Site Assessment

Hereford Point

Roman Road, Hereford HR4 9QP

Reviewed - 21-08-2024

8.2 Hard and soft landscaping

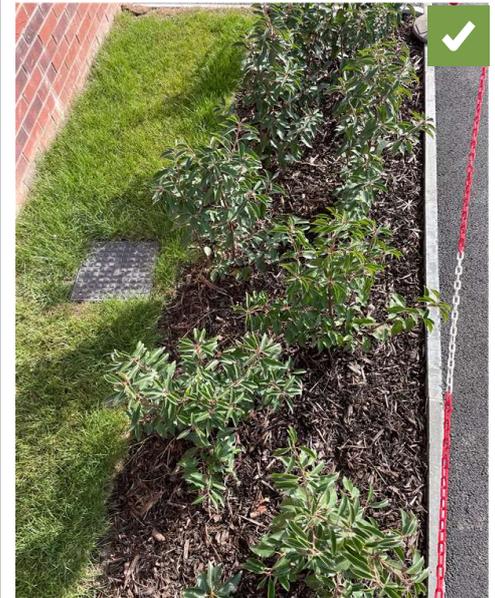
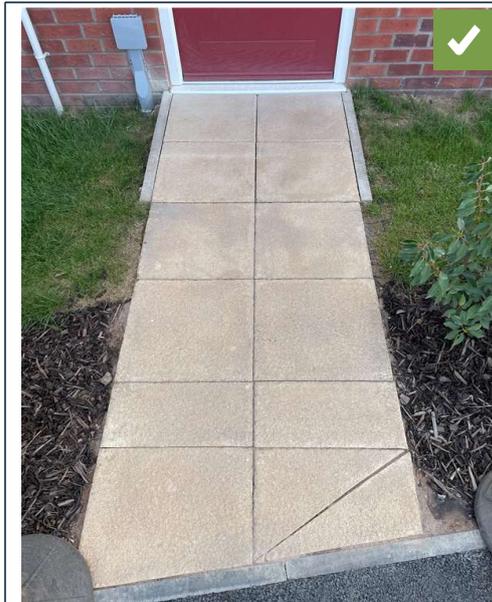
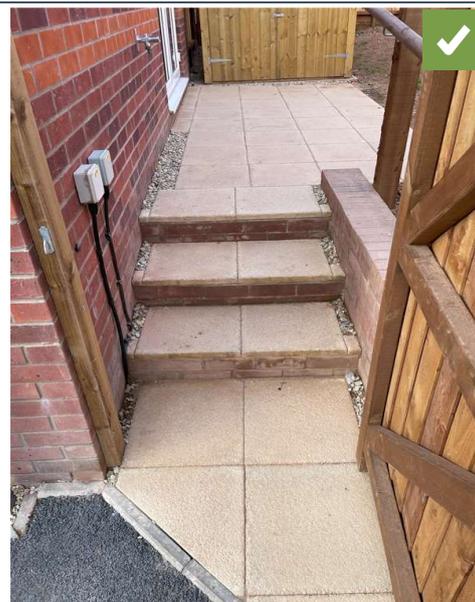
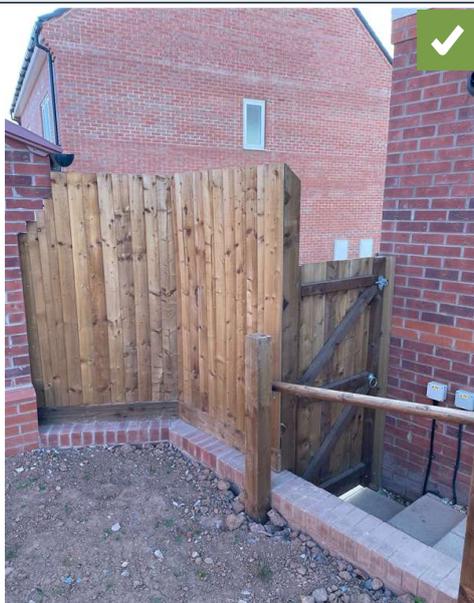
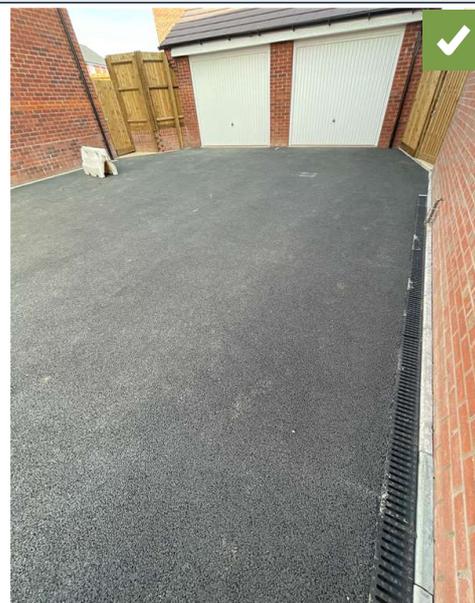
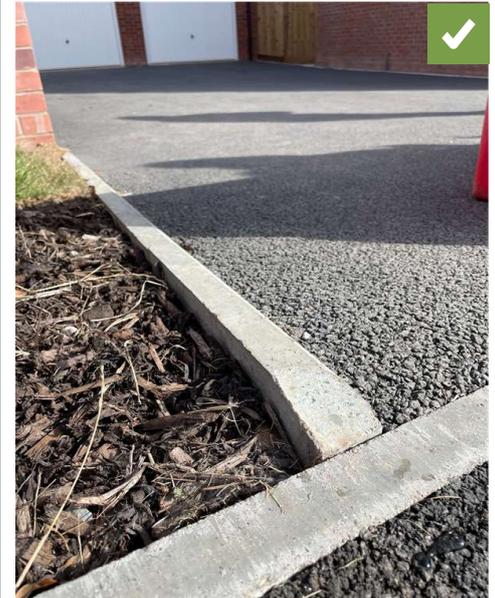
- Multiple plots were available with 7 viewed at this build stage, plots 364, 365, 366-367, 368-369 & 370.
- Component/product/material details: Part M / Paving slabs / Driveways / Turfed areas.
- Contractor details: Westpoint (Groundwork contractors).
- Contractor details: Eric Grabham (Landscaping contractor).
- Quality was outstanding and consistent across the plot seen.

- Landscaping was completed to a good standard.
- Good guidance was provided in the arrangement of the planting areas.
- Part M approach was installed in compliance with NHBC guidance and Approved Document M.
- Drainage slot of 10-18mm was provided to the door threshold.
- Paving slabs were installed to a good line and level.
- Fencing was neatly formed adjacent to the garage wall.
- Tarmac was installed to a consistent and level finish.
- Adequate drainage was provided to the driveway.
- The completed driveways had been protected from unauthorized use.
- Kerb edgings were installed around rainwater pipe entry into drains.
- The kerb edgings were neatly formed at points where there were changes in height.
